AGENDA

Town Planning & Building Committee

Tuesday, 2 July 2019 at 6.30pm

Date:	3/04/2019	Drwn:	JC
Job No:	1817	Dwg No.:	A101
		Rev	4
The builder must verify all dimensions on site before commencing any work or shop dwgs.

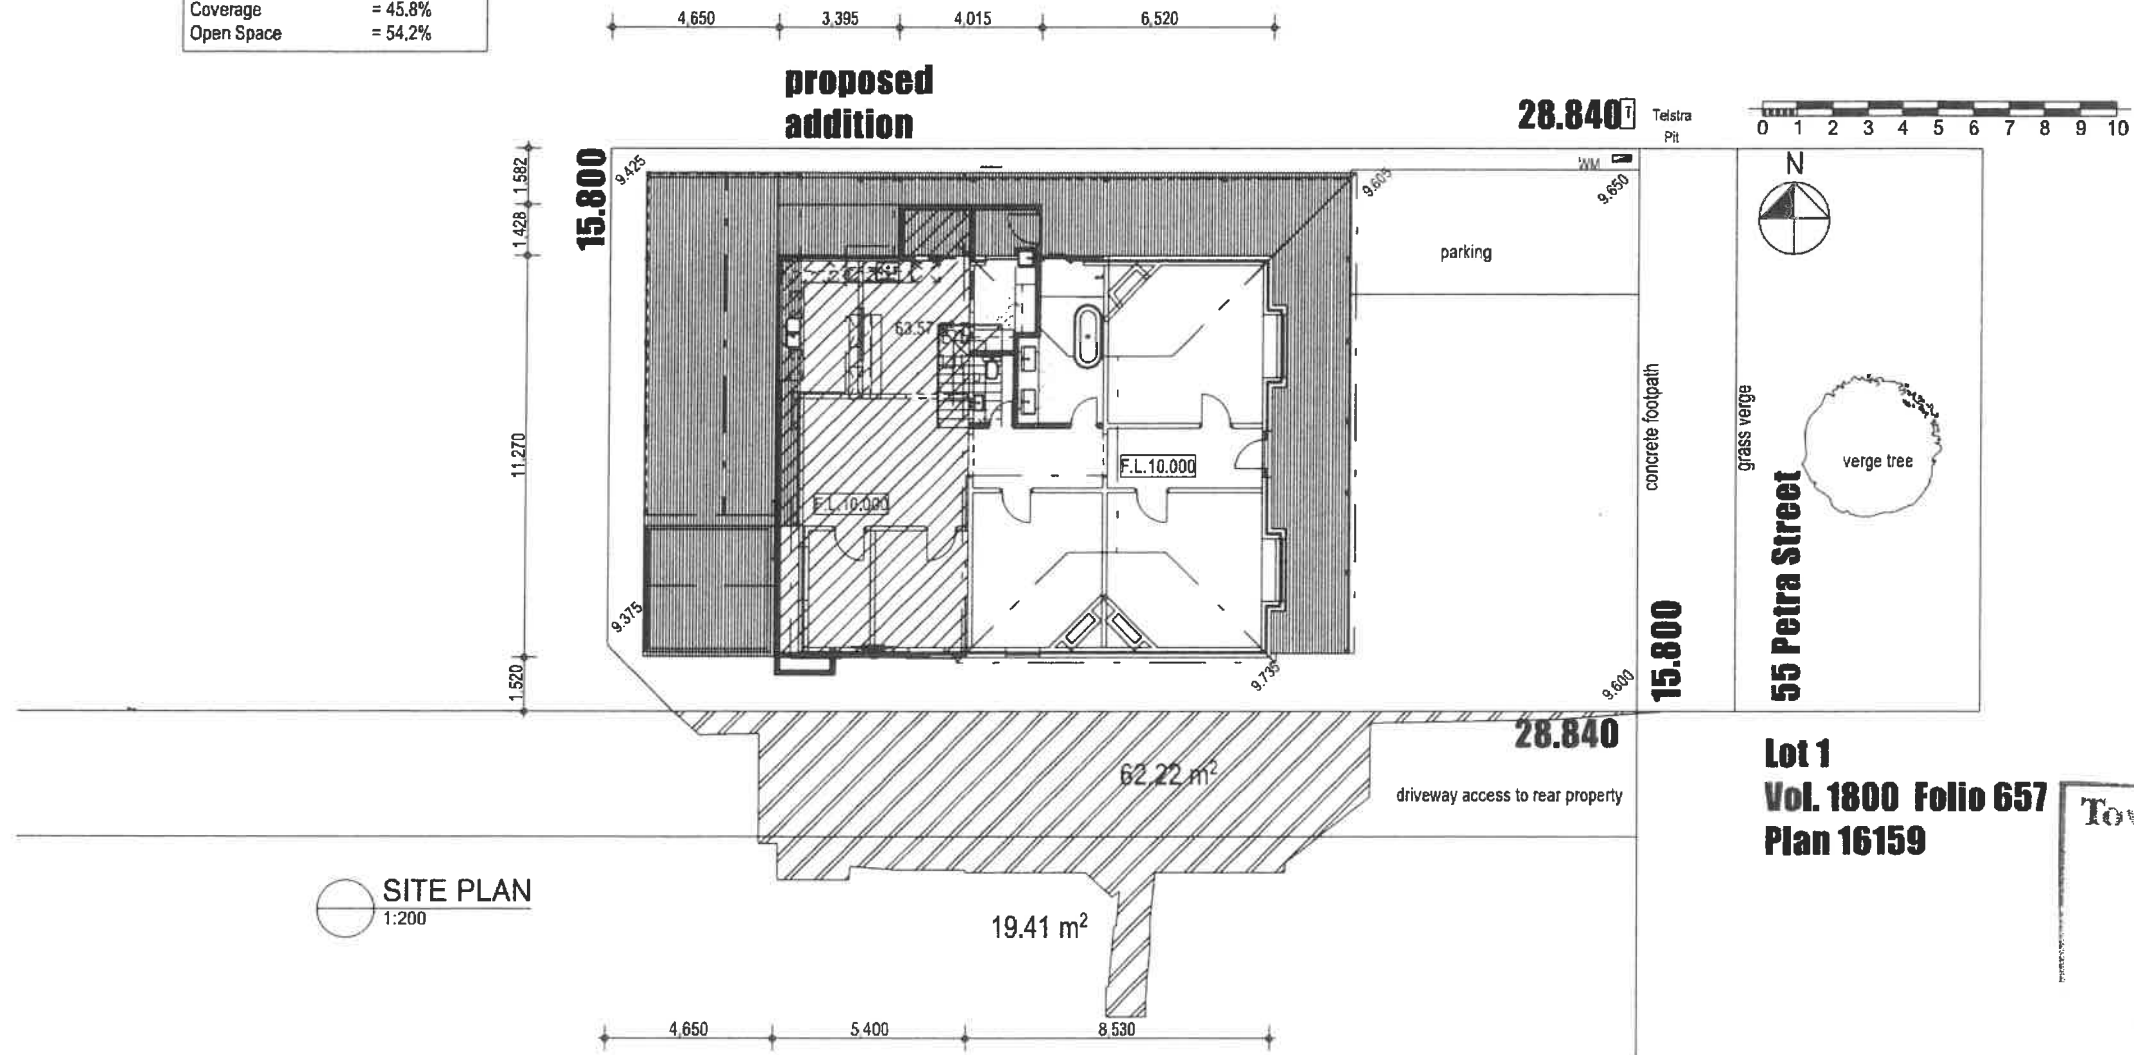
- Committee commented that the proposal does not take into account the significance and character of the existing building.
- Committee is not supportive of the proposed change to the roofline.
- The Committee do not support the development as a whole as it was deemed not to contribute to the existing architecture and does not comply with the Residential Design Guidelines in respect to position of bulk and scale of upper storey.

The site is classified category B under the Municipal Inventory. The Town's assessment of the proposal supports the applicant's response that the proposal (as outlined in the amended plans) does not interfere with the existing ridge, roof form nor the chimneys. The second storey element is forward of the existing ridgeline and protects and maintains the existing chimneys. The existing dwelling retains its presence with regard to street presentation.
